REMARKS

AMENDMENTS TO THE DRAWINGS

ANNOTATED SHEET SHOWING CHANGES

FIG. 4B

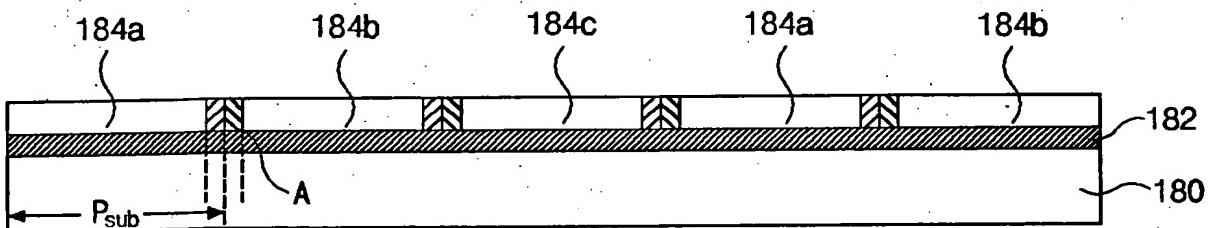
In the Office Action, the drawings are objected to because of reference numeral "112" in Fig. 4B. Applicants have amended Figs. 4B, 6 and 10 to cure minor typographical errors in the drawings. No new matter is added to the drawings. The attached Replacement Sheets are submitted to replace the original sheets including Figs. 4B, 4C, 6, 9 and 10, and the "Annotated sheets showing changes" shows the changes made in red in Figs. 4B, 6 and 10. In view of these amendments, Applicants respectfully request the withdrawal of the objection to the drawings.

In Fig. 4B, the reference number “112” is changed to “142”;

FIG. 6

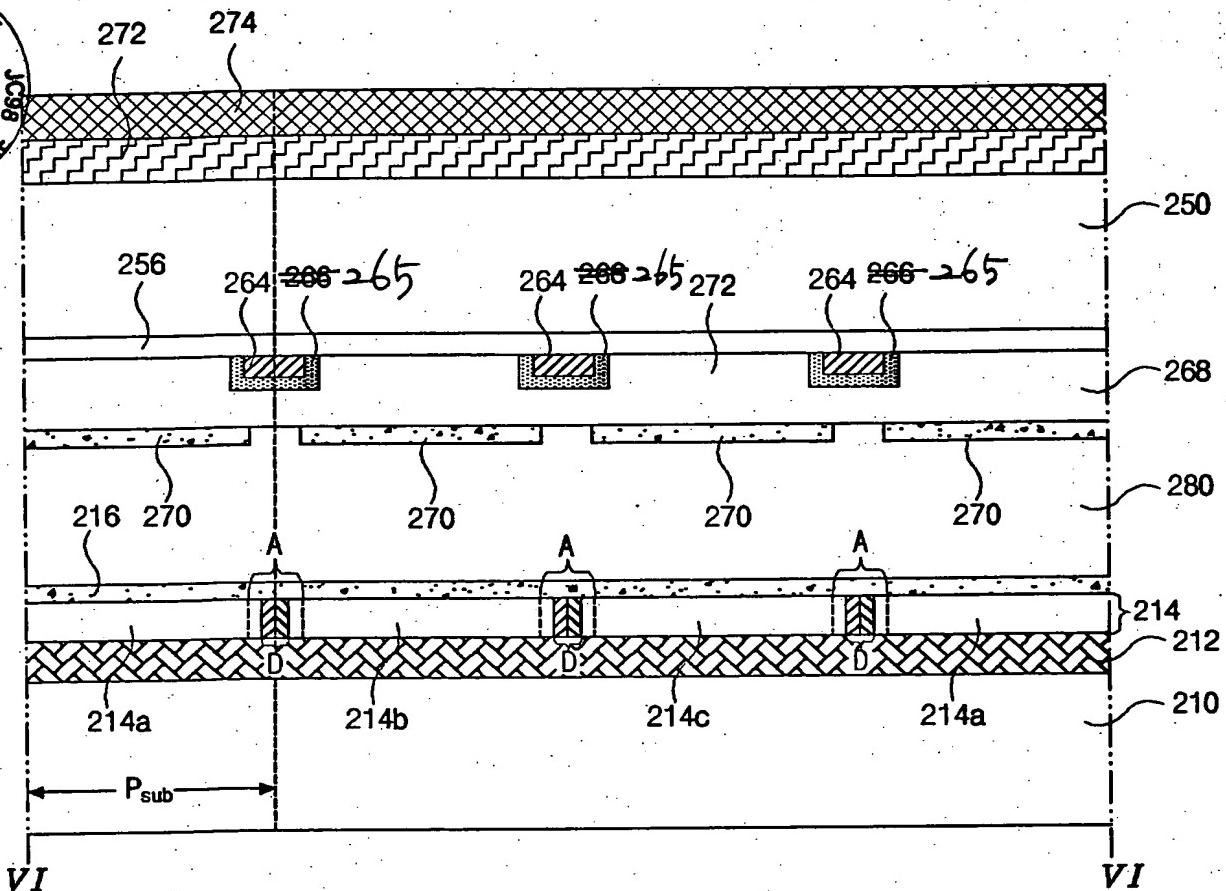
In Fig. 6, the reference number “266” is changed to “265”; and

FIG. 10

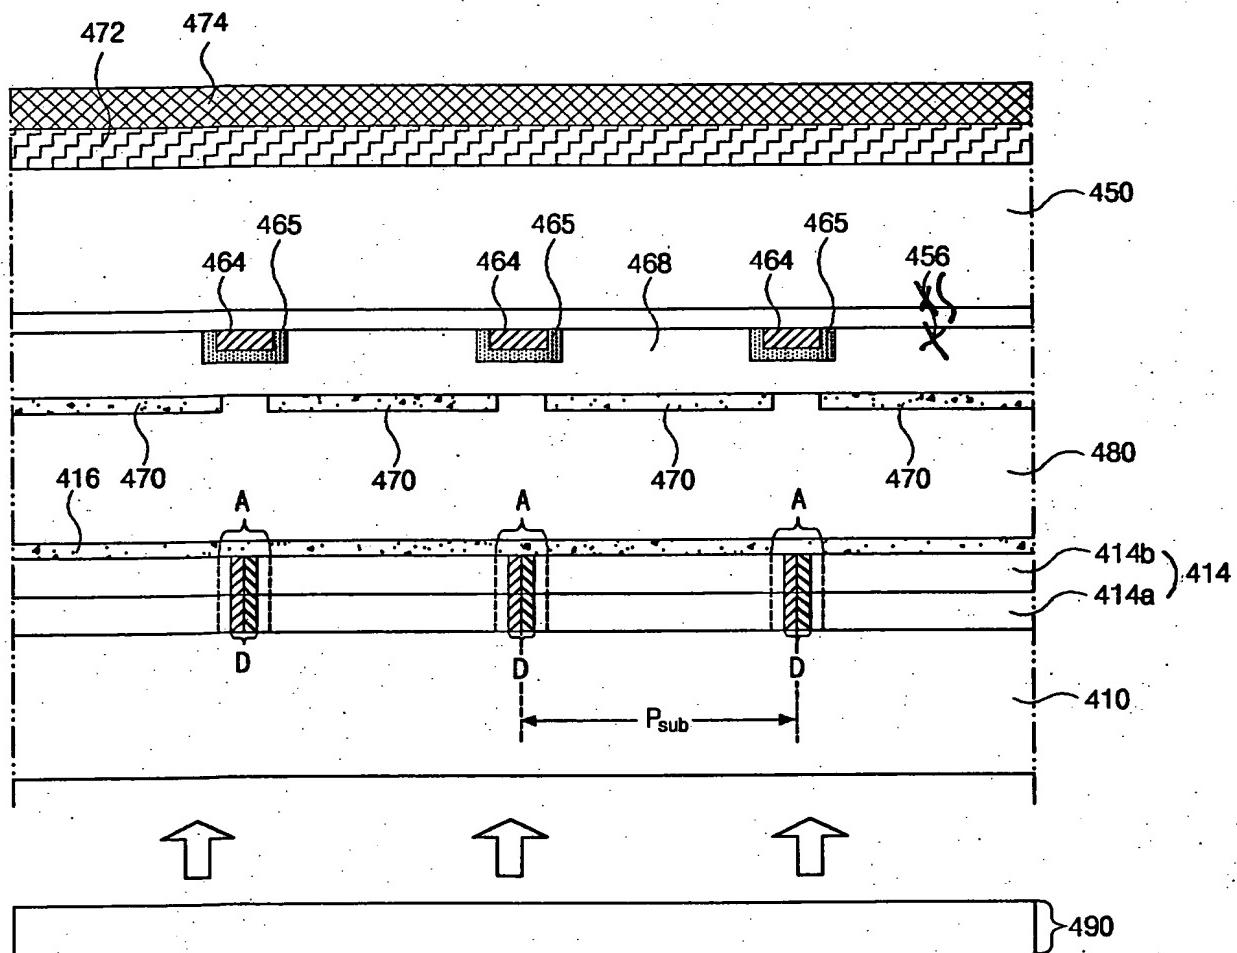
In Fig. 10, the reference number “456” refers to the gate insulating layer, not the passivation layer.
